9/13/96	Class B Concrete changed to Class A.
6/14/96	Notes added to clarify plans.
DATE	REVISION
STATE OF HAWAII DEPARTMENT OF TRANSPORTATION HIGHWAYS DIVISION	
DRAINAGE PLAN	
KALANIANA'OLE HIGHWAY RESURFACING	
Kailua Rd. to Hilo St.	
Project No. 72A-01-96M	
Scale: 1"=40'	Date: May 1996
SHEET No. 44 OF 44 SHEETS

KALANIANA'OLE HIGHWAY RESURFACING

Project No. 72A-01-96M

SECTION A

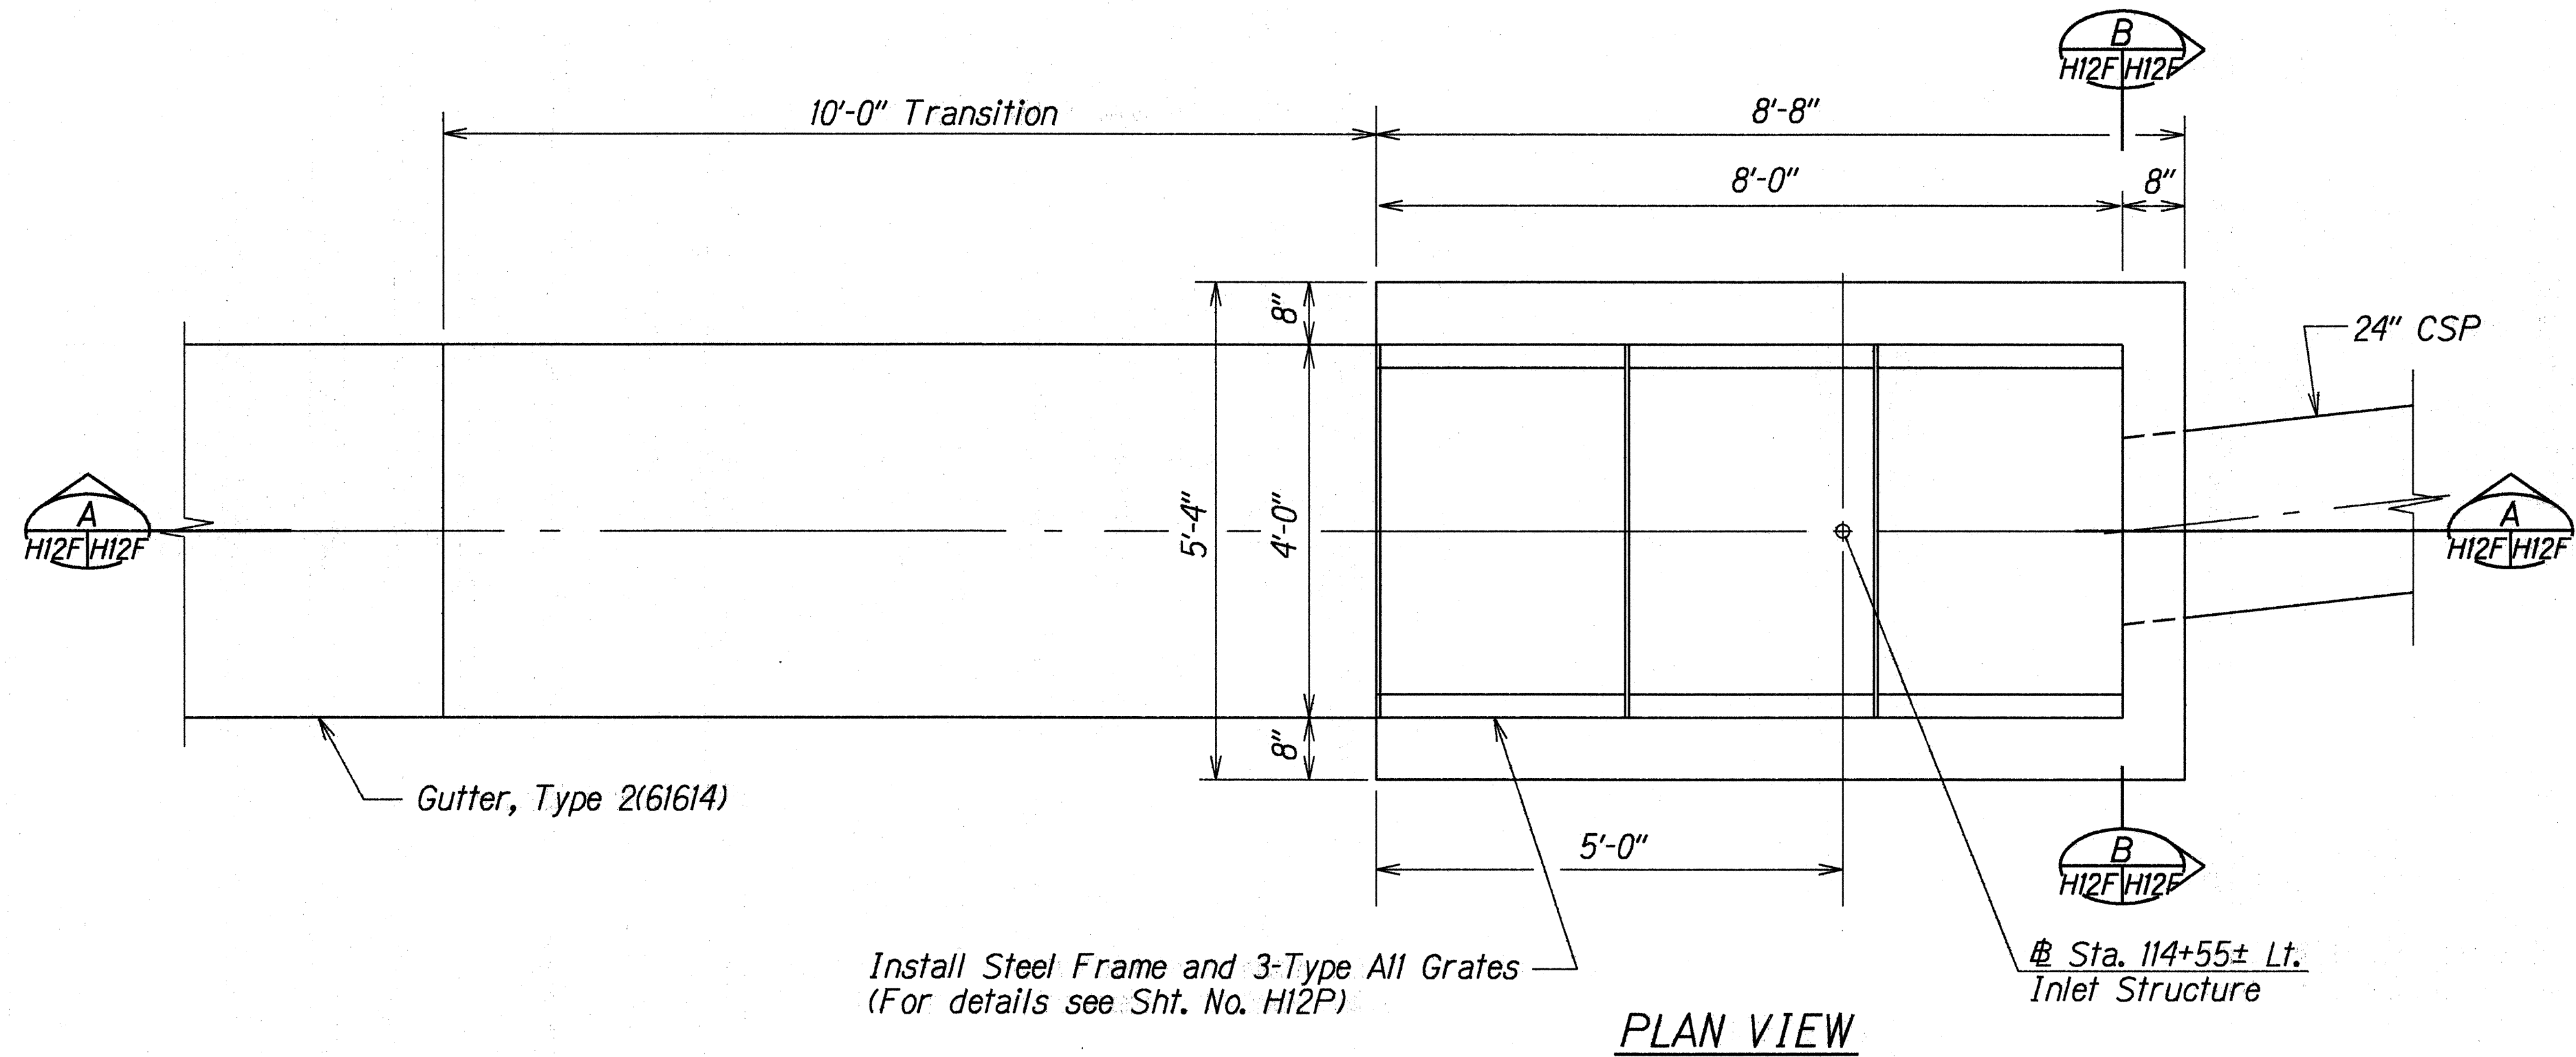
DATE	REVISION
4/15/97	Revised Inlet Structure for safety.
6/14/96	Details added to complete drainage plan.
STATE OF HAWAII DEPARTMENT OF TRANSPORTATION HIGHWAYS DIVISION DRAINAGE DETAILS KALANIANA'OLE HIGHWAY RESURFACING Kailua Rd. to Hilu St. Project No. 72A-01-96M Scale: 3/4"=1'-0" Date: May 1996	
SHEET No. HI2F OF 12 SHEETS

Chip concrete around existing reinforcing. Cut reinforcing bar 1" below saw cut. Fill chipped out area with epoxy mortar.

C.O. ADD. 55S-9

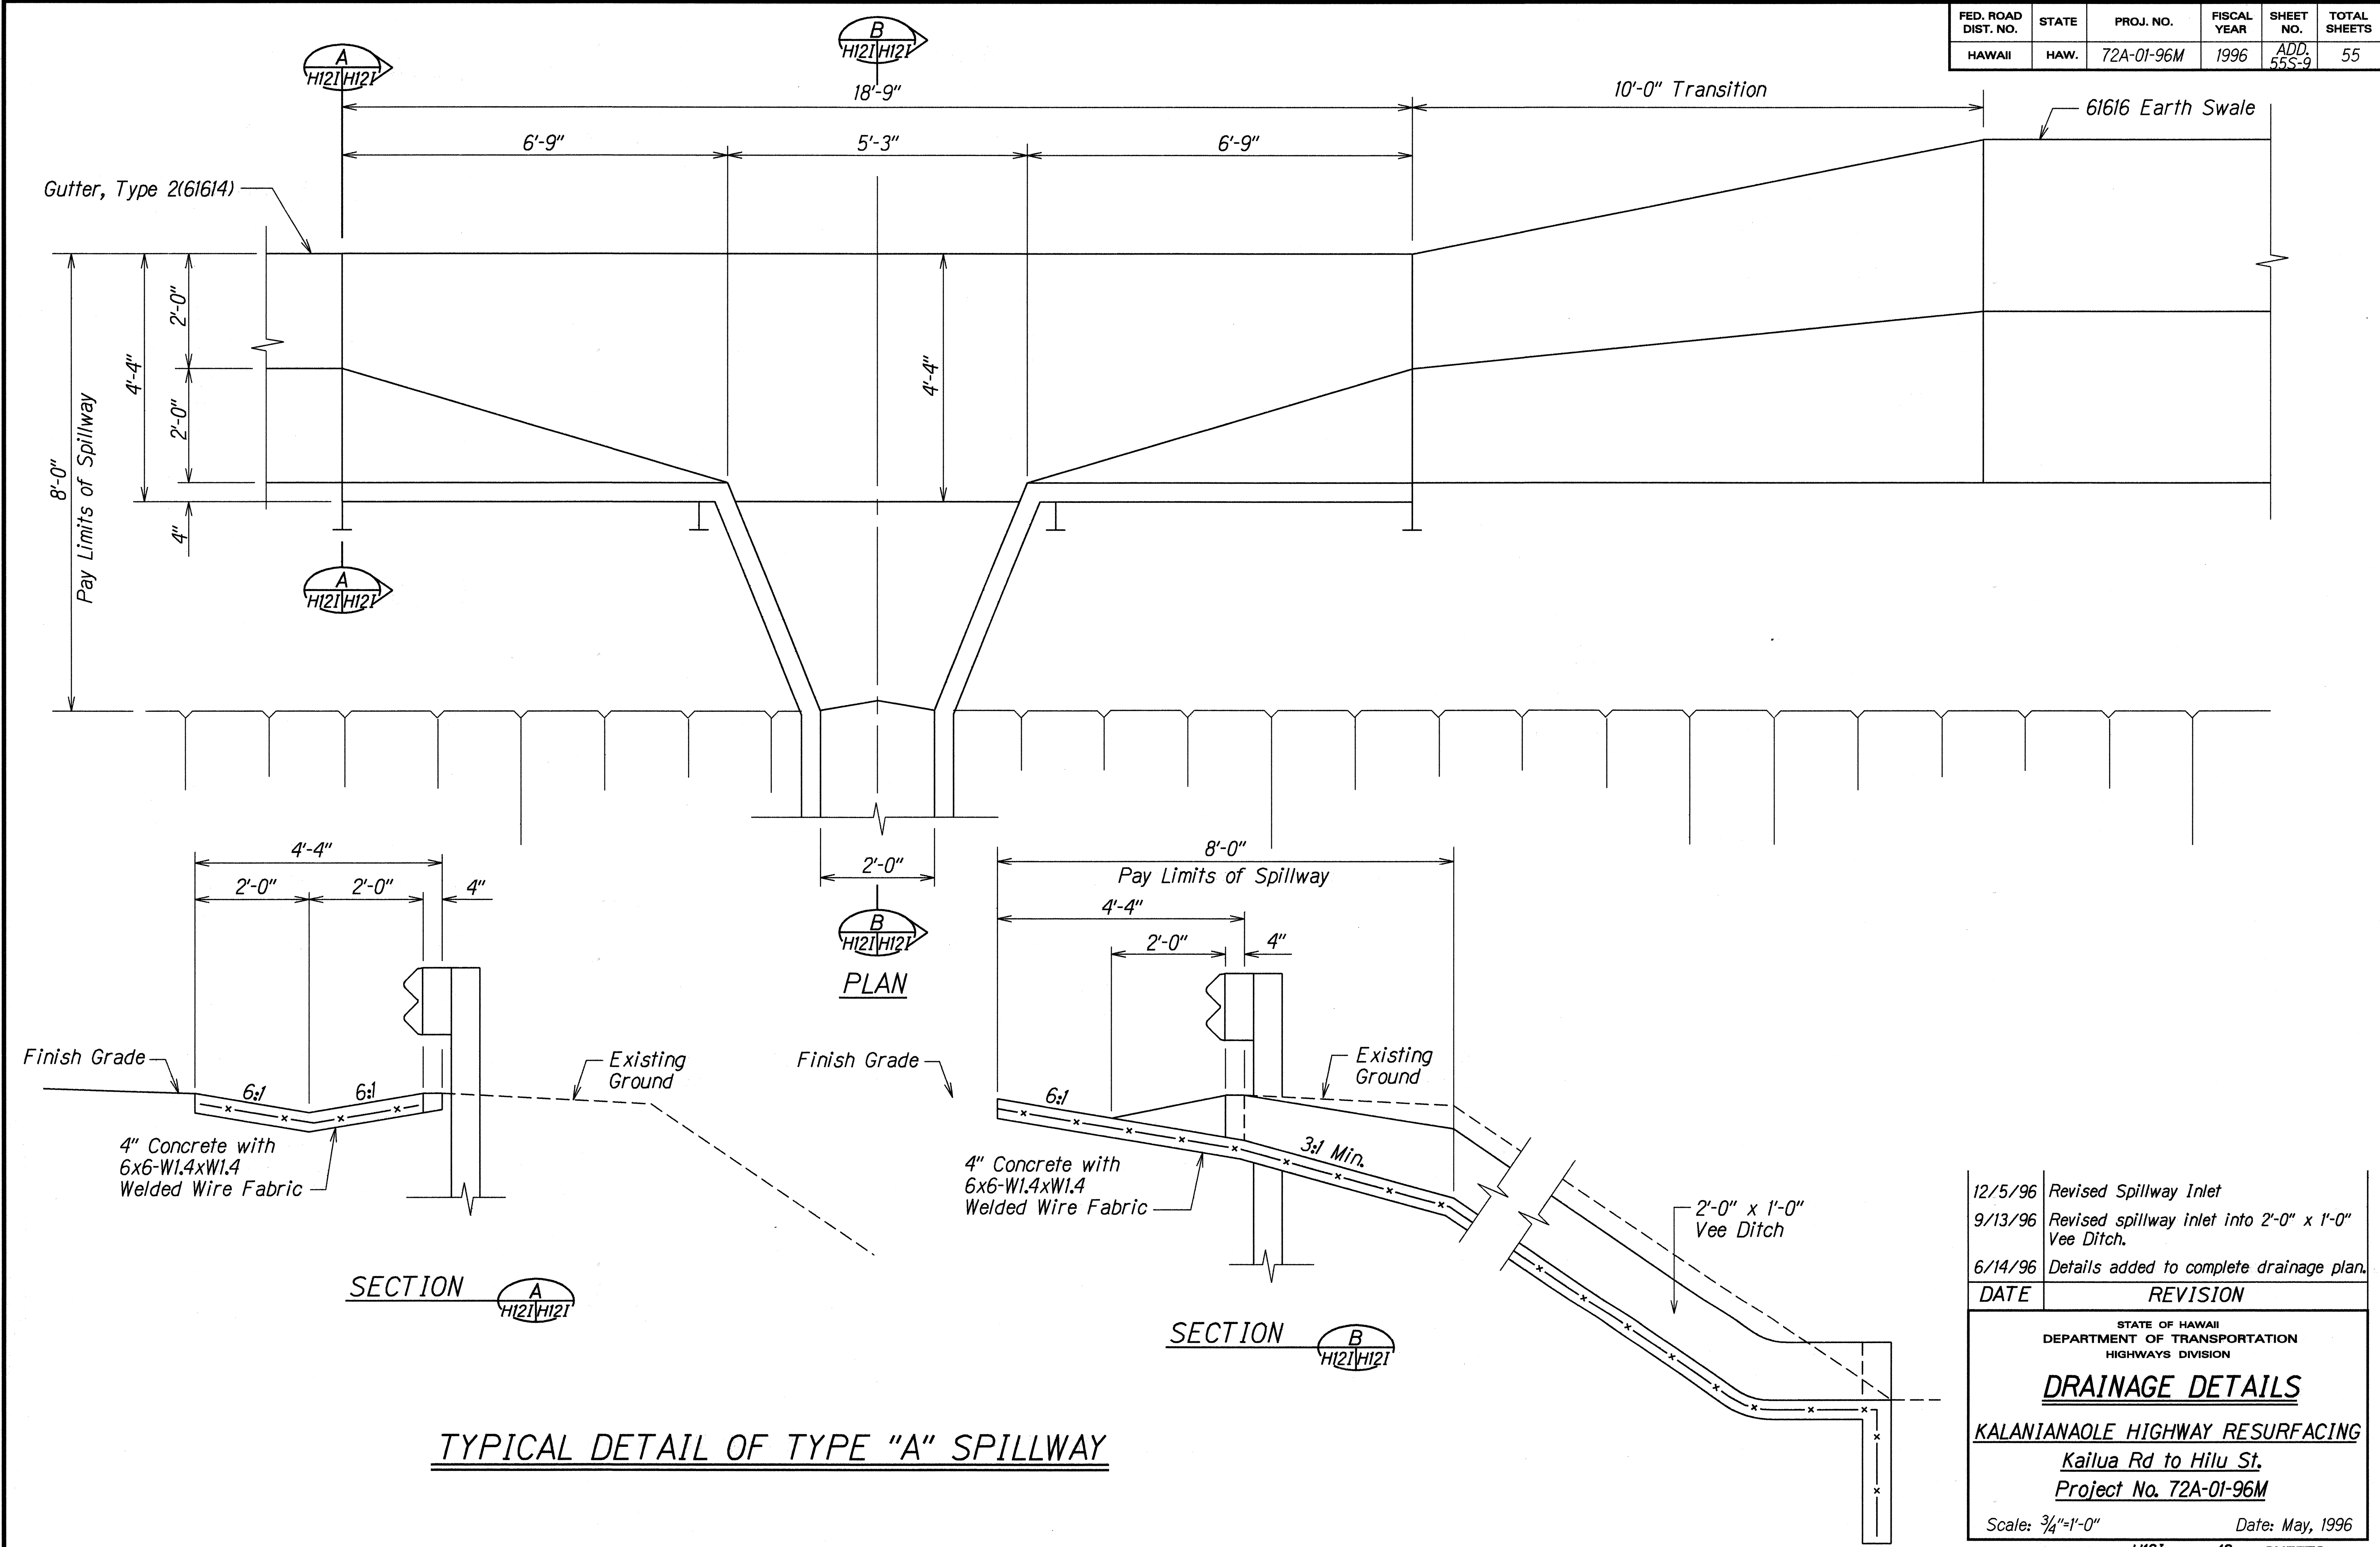
12/5/96	<i>Revised Spillway Inlet</i>
9/13/96	<i>Revised spillway inlet into 2'-0" x 1'-0" Vee Ditch.</i>
6/14/96	<i>Details added to complete drainage plan.</i>
DATE	REVISION
